## **EXHIBIT 11-A**

# FACT SHEET EXCEPTIONS TO MANDATORY DESIGN STANDARDS

SM101 RAMP METERING PROJECT  
 04-SM-101 PM 0.0/26.2  
 04-373-2A7900

SB 101 / Harney Bay on-ramp

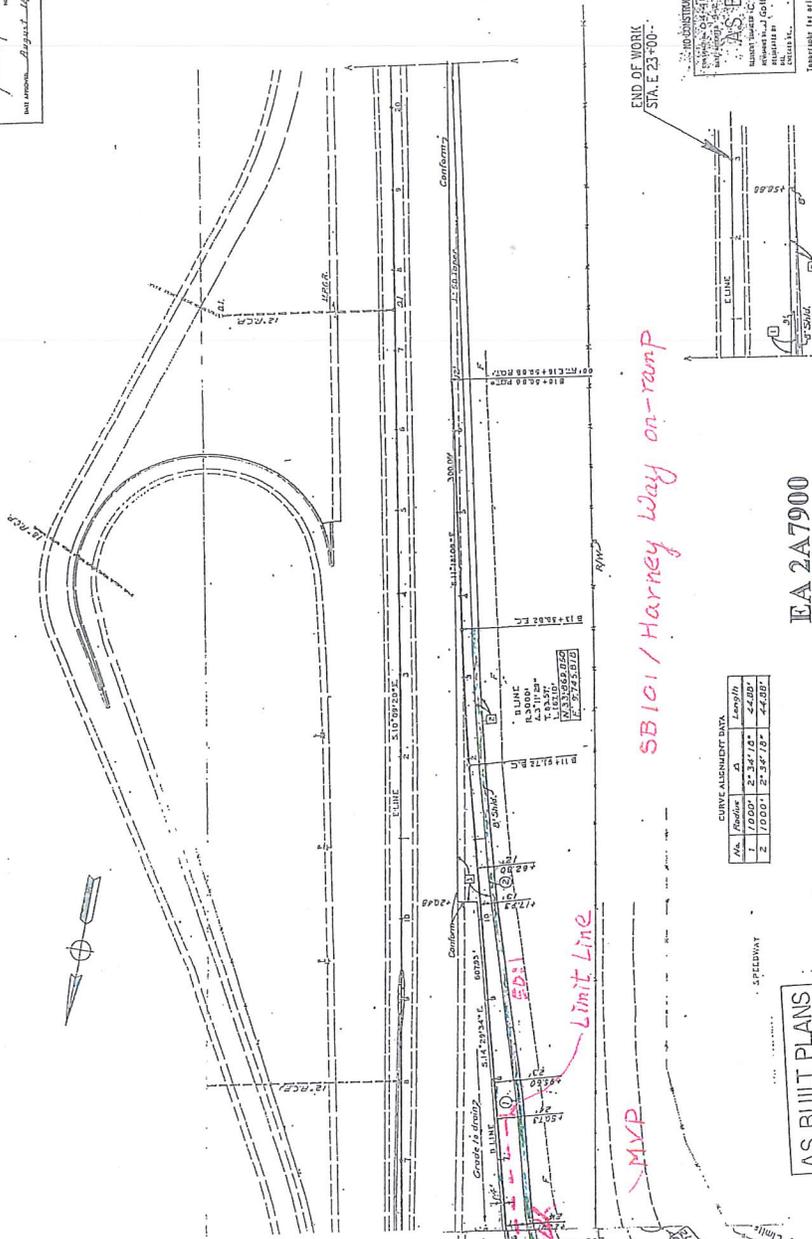
SB101/Harney Way Hook On-Ramp: The existing 162 ft radius curve approaching the freeway has nonstandard superelevation with an e rate of 0.08. No superelevation improvements are proposed for this ramp and the existing nonstandard superelevation will be maintained.

The existing hook on-ramp was constructed under project EA# 415104. This on-ramp currently varies from 2 to 1 lane wide, with 4 ft left and 8 ft. right shoulders. The ramp has an operational ramp metering system metering for post game and after special events from nearby Candlestick Park. When metered, this on-ramp operates as a 2-lane mixed flow metered on-ramp. This project proposes to overlay, re-stripe ramp to a standard 2-lane metered on-ramp with standard shoulders, and upgrade existing ramp metering equipment to current standards.

The existing superelevation rate of 0.08 occurs just east of the intersection where the ramp terminates, by Figure 202.2, the maximum comfortable speed is 45mph which is higher than the 25 mph design required for the ramp terminus. The roadway tangent section between the ramp entrance and the beginning of the curve as well as curve radius and length of curve are very short. Upgrading the existing nonstandard superelevation rate in accordance with the 2006 Highway Design Manual would involve upgrading the superelevation rate to 0.12. This Standard superelevation rate and transition cannot be attained within this curve. In addition, the accident history of the on-ramp, have shown

SB101 / Produce Ave  
 EA 2A7900

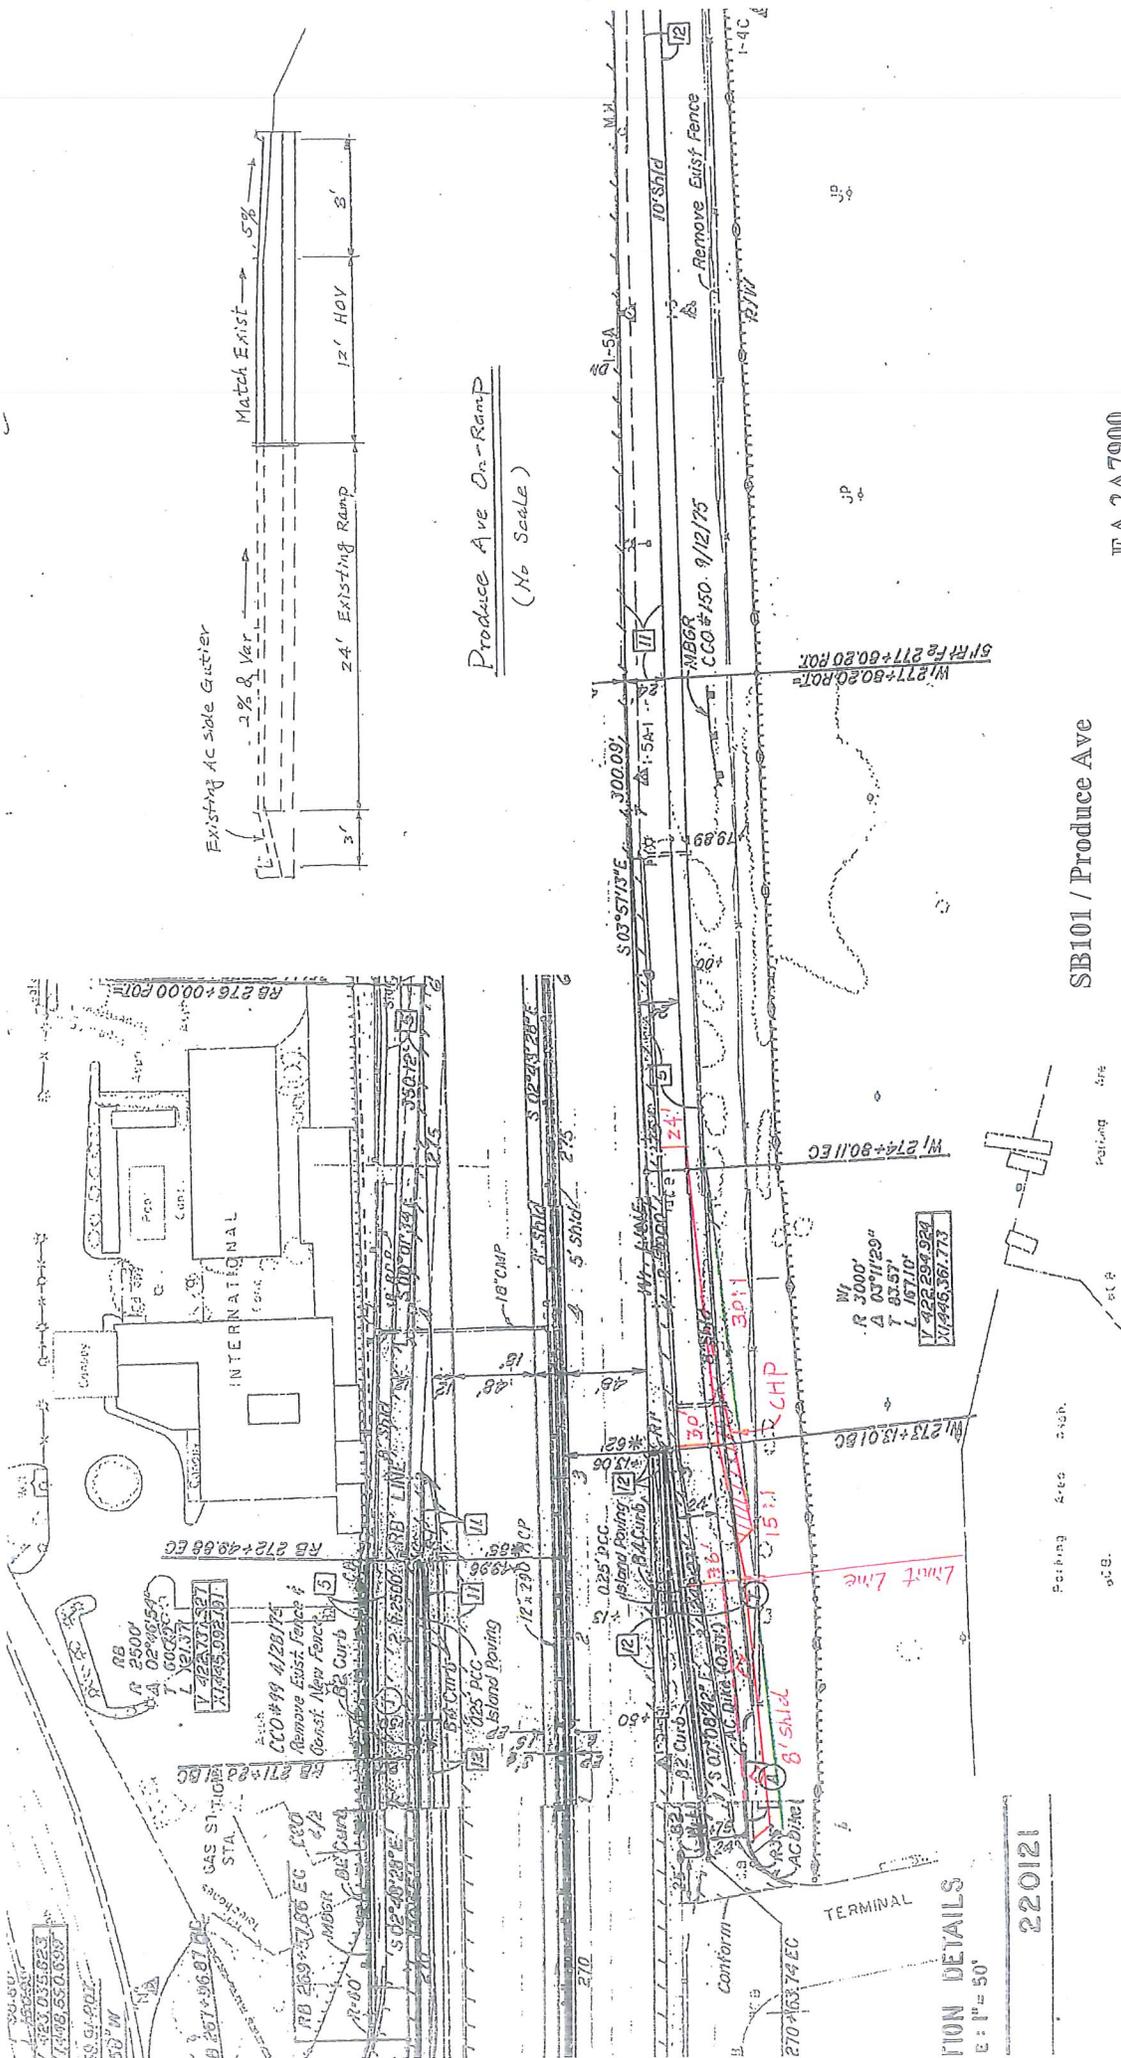
SB101/Produce Avenue Diagonal On-Ramp: The existing 3000 ft radius curve approaching the freeway has nonstandard superelevation with an e rate of 0.02. No superelevation improvements are proposed for this ramp and the existing nonstandard superelevation will be maintained.

The existing on-ramp was constructed under project EA# 220124. The existing on-ramp is a 2 lane on-ramp (24ft wide) with 3 ft. AC side gutter/B4 curb left and 8 ft. right shoulders. This ramp will be widened to 3 lanes, with 1 HOV preferential lane and 2 mixed flow lanes, and with standard shoulders. The widening will conform to the existing ramp superelevation.

At the existing superelevation rate of 0.02, by Figure 202.2, the maximum comfortable speed is 70mph. Upgrading the existing nonstandard superelevation rate in accordance with the 2006 Highway Design Manual would involve upgrading the superelevation rate to 0.04 at which the maximum comfortable speed is 75 mph. This gain in benefits is beyond the maximum driving speed limit of this ramp roadway and would create a relatively significant disruption to traffic and local business. Additionally, accident history has shown that the existing nonstandard superelevation has not caused accidents along the ramp.

SB101 - Fashion Island On-Ramp

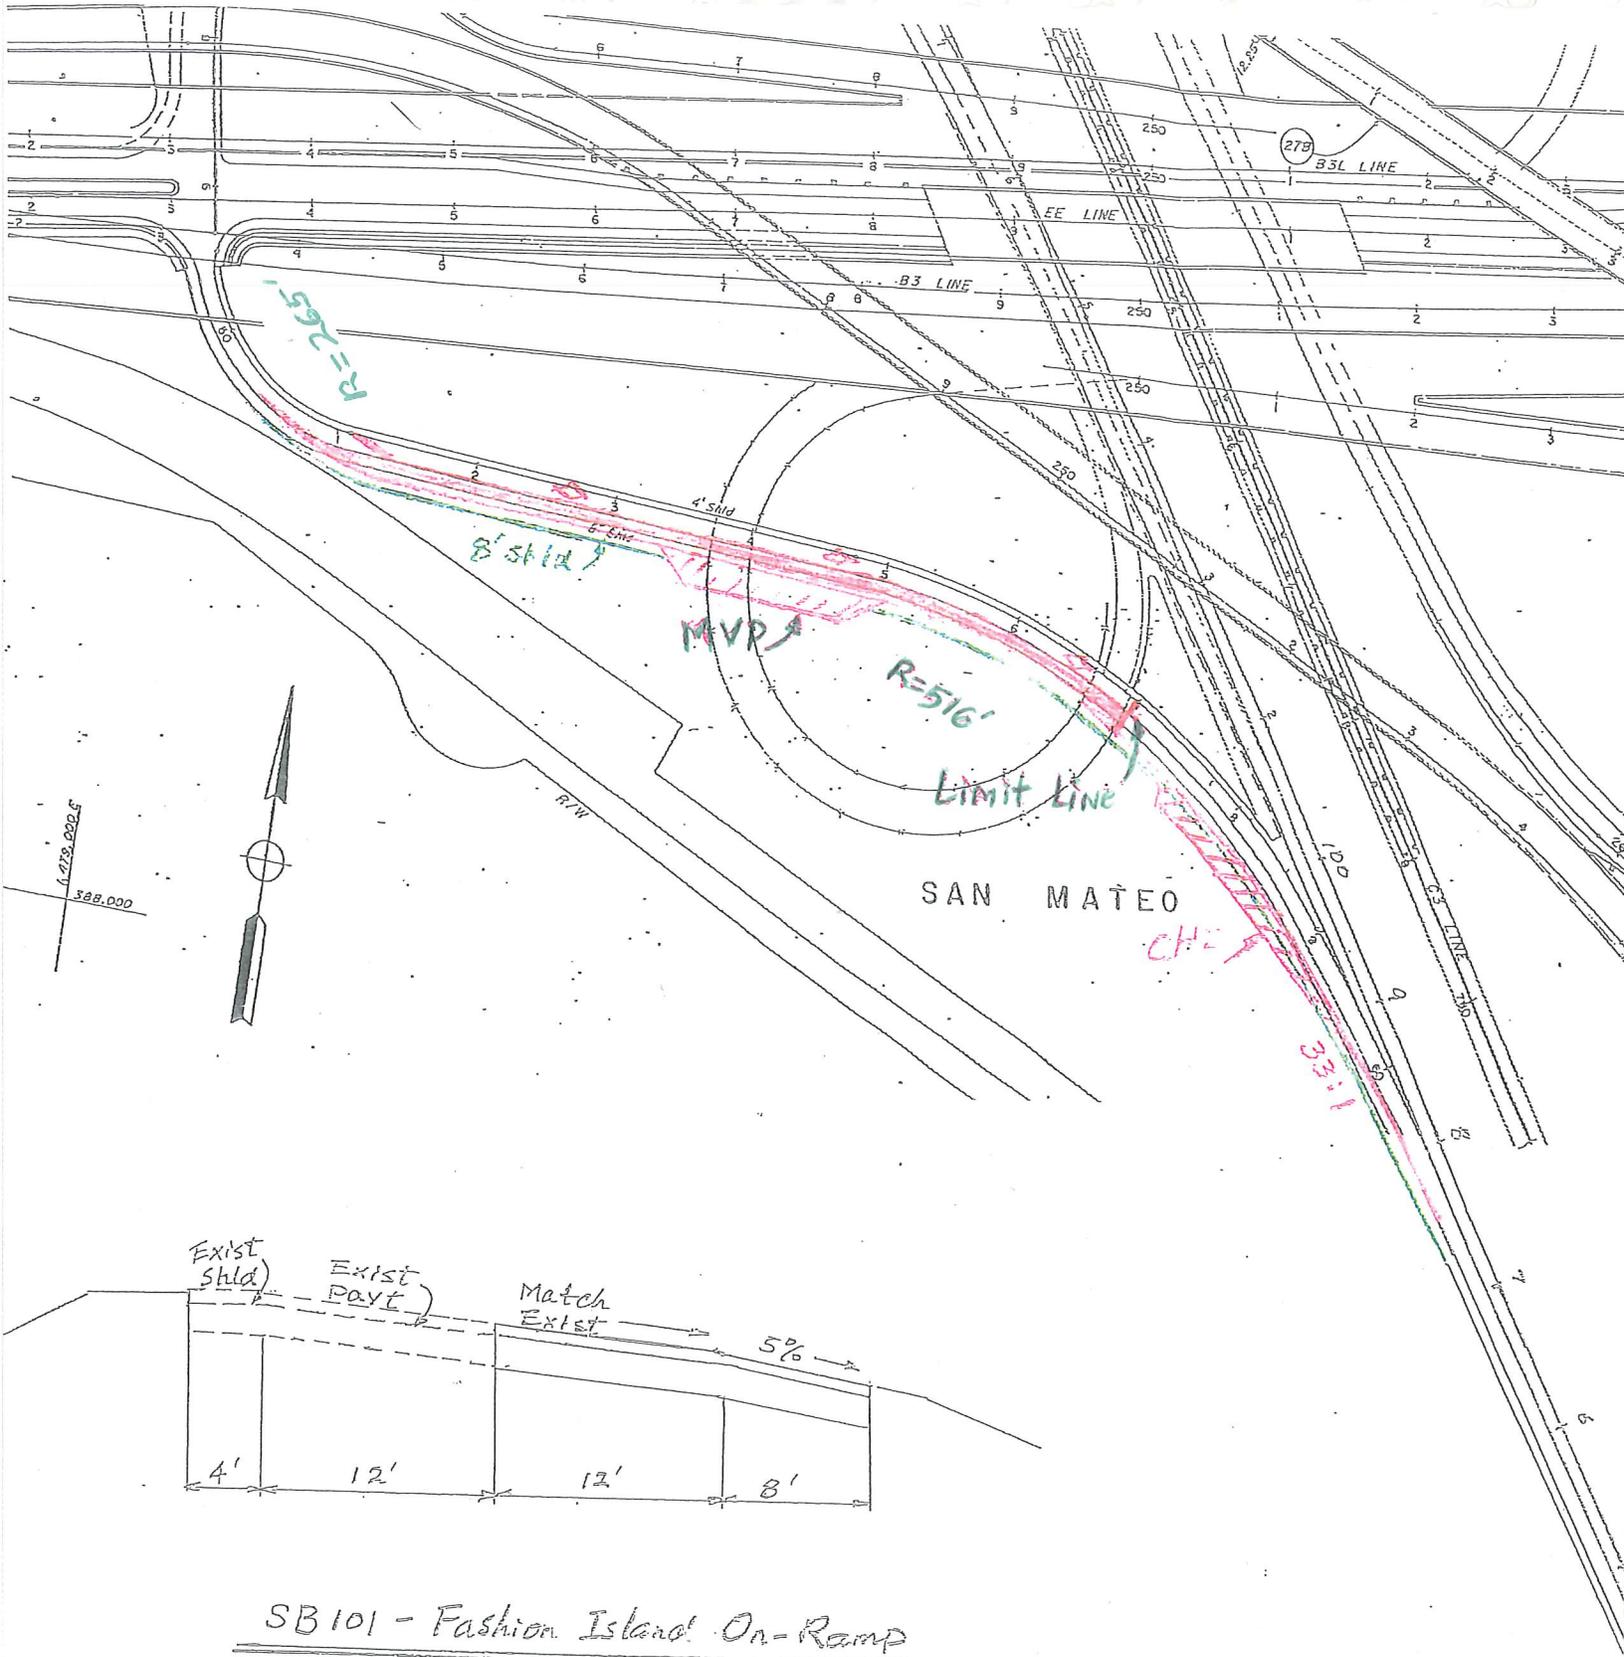
SB101/Fashion Island Boulevard Diagonal On-Ramp: The existing 516 ft radius curve approaching the freeway has nonstandard superelevation with an e rate of less than 0.03. No superelevation improvements are proposed for this ramp and the existing nonstandard superelevation will be maintained.

This on-ramp has 12 ft. lane width with 4 ft. left and 8 ft. right shoulders. This ramp will be widened to 2 lanes, with 1 mixed flow and 1 HOV preferential lane, and operate as a 2-lane metered on-ramp up to the limit line. The proposed HOV lane will have 12 ft lane width with 8 ft. right shoulders.

With the existing ramp condition, the superelevation of this ramp cannot be corrected because of geometrical constraint by the adjacent 101 freeway, the Route 92 overpass, and the Route 92 to SB 101 connector on-ramp. At the existing superelevation rate of 0.03, by Figure 202.2, the maximum comfortable speed is 38mph. Upgrading the existing nonstandard superelevation rate in accordance with the 2006 Highway Design Manual would involve upgrading the superelevation rate to 0.12 at which the maximum comfortable speed is 47 mph. the gain in benefits is insignificant as compared to the costs of rebuilding the ramp, and additional paving.

SB101 / Harney Way on-ramp

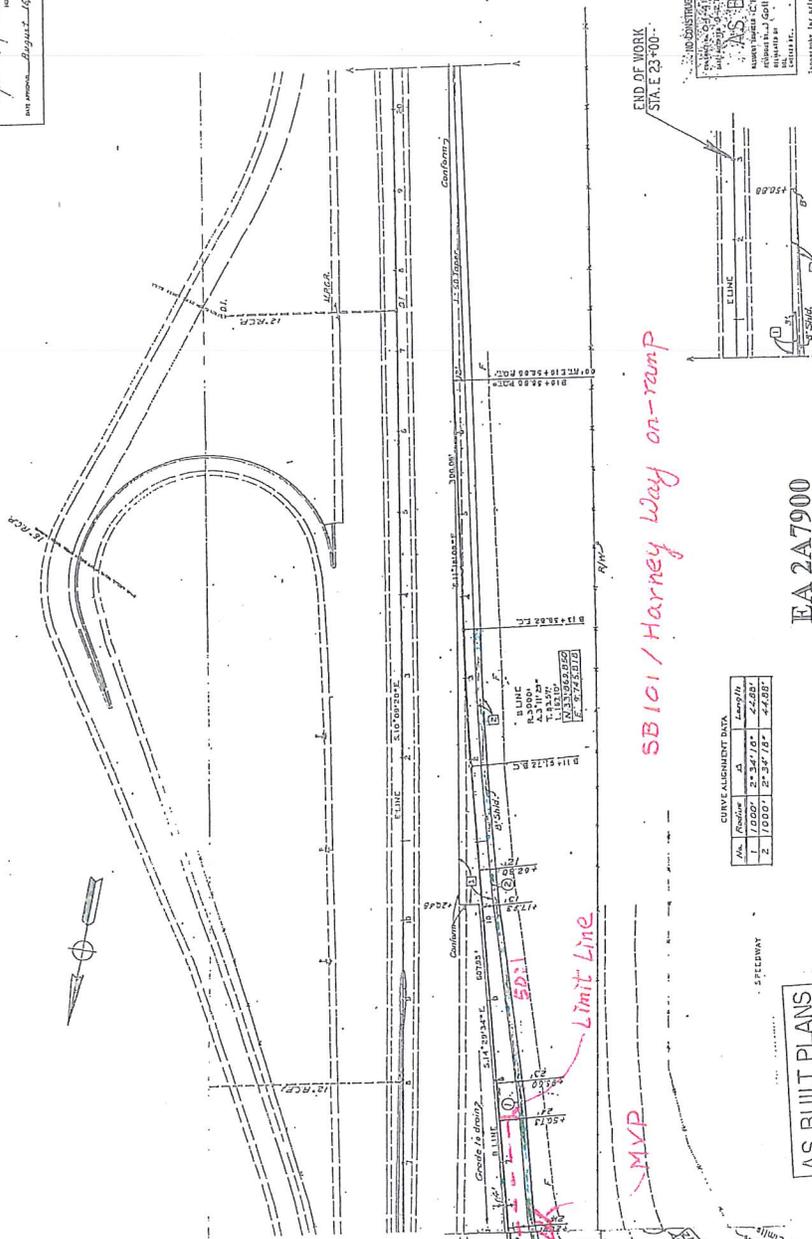
This existing 162 ft radius curve with existing nonstandard e rate of 0.08 approaching the freeway has nonstandard superelevation transition of two-thirds runoff length 93.08 feet.

The existing superelevation rate of 0.08 with two-thirds of runoff length 93.08 feet occurs just east of the intersection where the ramp terminates. By Figure 202.5A, the minimum two-thirds of the runoff length for this ramp is 100 feet. The roadway tangent section (93.08 feet) between the ramp entrance and the beginning of the curve as well as curve radius and length of curve are very short, because of geometrical constraint by the Harney Way off-ramp, Beatty Ave and Alana Way. Upgrading the existing nonstandard runoff length in accordance with the 2006 Highway Design Manual would involve upgrading the superelevation rate to 0.12 and transition 240 feet. This Standard superelevation rate and transition cannot be attained within this curve. In addition, the accident history of the on-ramp, have shown that the existing nonstandard superelevation has not caused accidents along the ramp. Thus, no safety problems are expected to result from the existing superelevation rate and transition.

Attachment L2-3

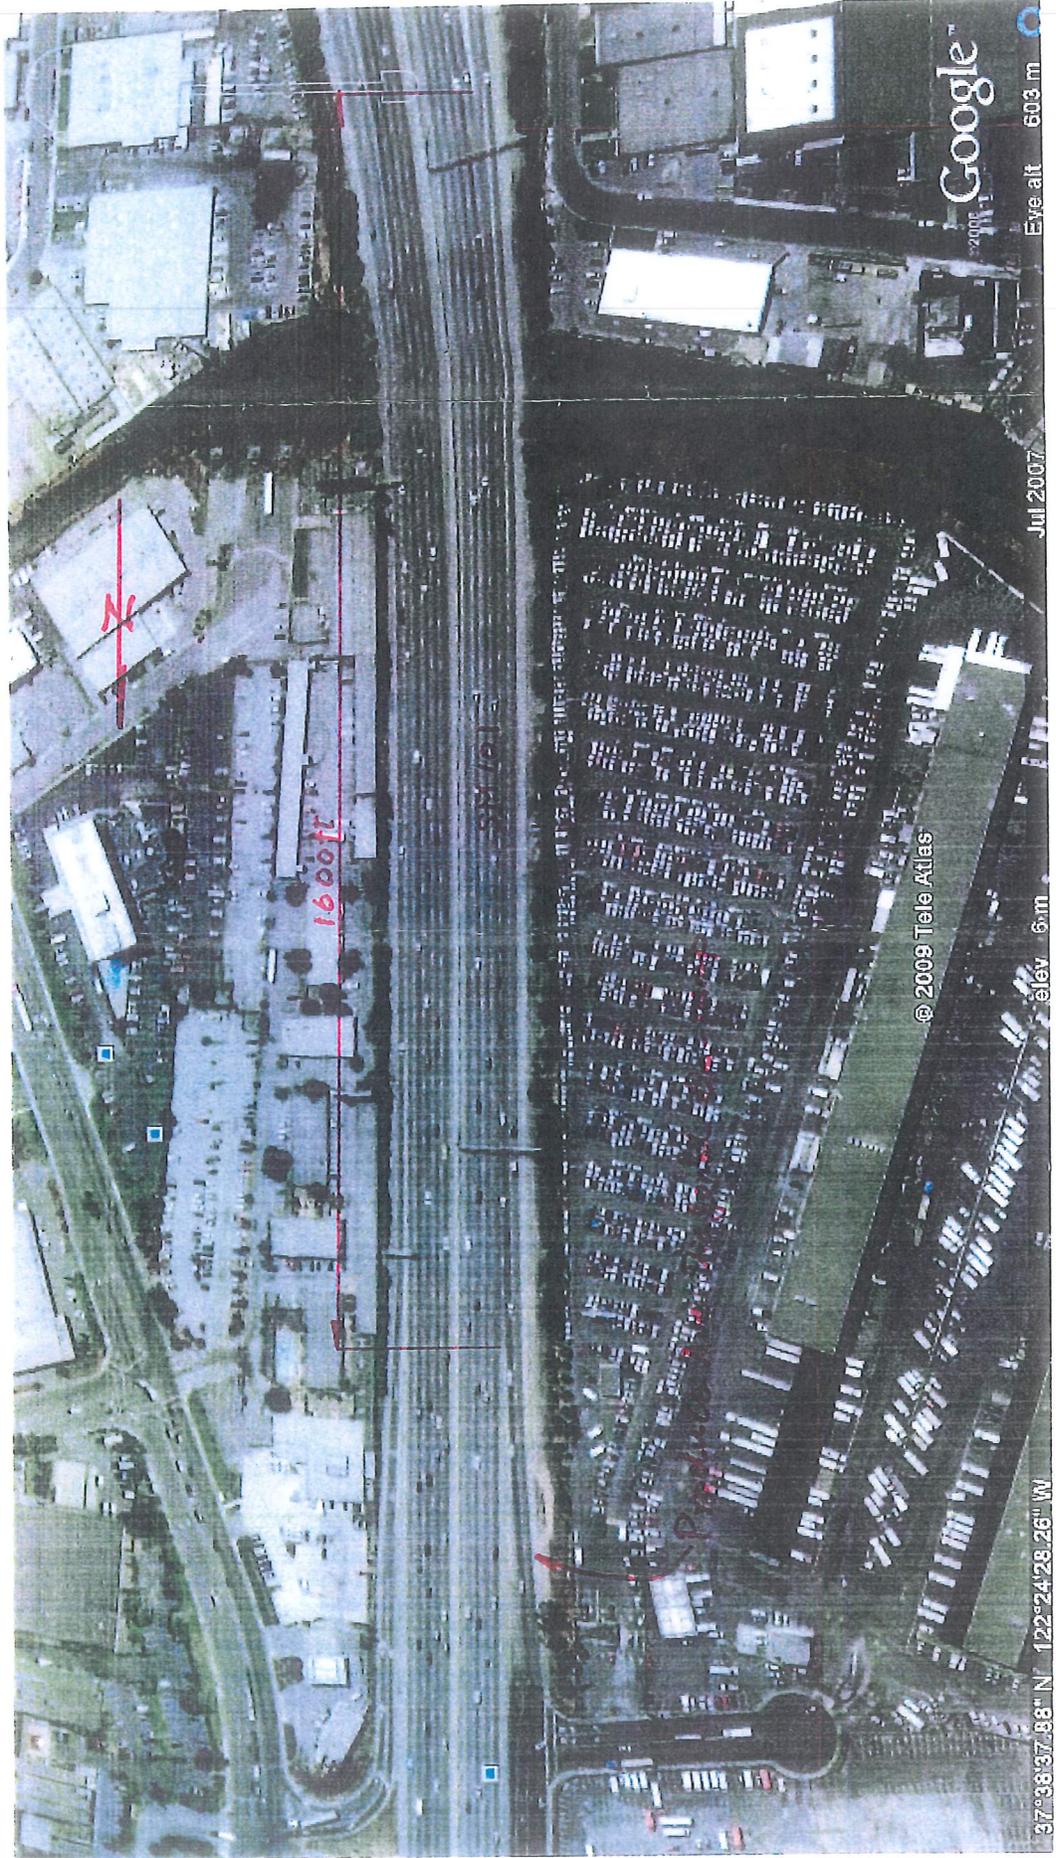
The proposed compound lane drop transition taper rate (3 lanes to 2 lanes) has nonstandard average ratio of 22.5:1(longitudinal to lateral).

The geometrics of this ramp are constrained by the existing interchange geometry, the weaving length, the adjacent local city street (Produce Ave and Terminal Ct.), and available queue storage length on the on-ramp (during metering hours).

The existing configuration of the on-ramp has the minimum weaving length of 1,600 feet from Produce Ave on-ramp to the next off-ramp (the SB101 to WB380 connector off-ramp), which meets the requirement of index 504.7 of HDM (Highway Design Manual). In order to have available storage for queued cars behind the proposed ramp meter limit line, 162 feet of storage length will be provided for each on-ramp lane (between local street intersection and ramp meter limit line).

With the constrained geometric conditions, a compound lane drop transition rates are considered for this on-ramp. A 15:1 taper is provided from the limit line to the end of curb (between freeway mainline and on-ramp); and a 30:1 taper is provided from the end of curb to end of the third lane transition to two lanes. The average taper rate for this on-ramp is 22.5:1, which is above the mandatory minimum of 15:1.
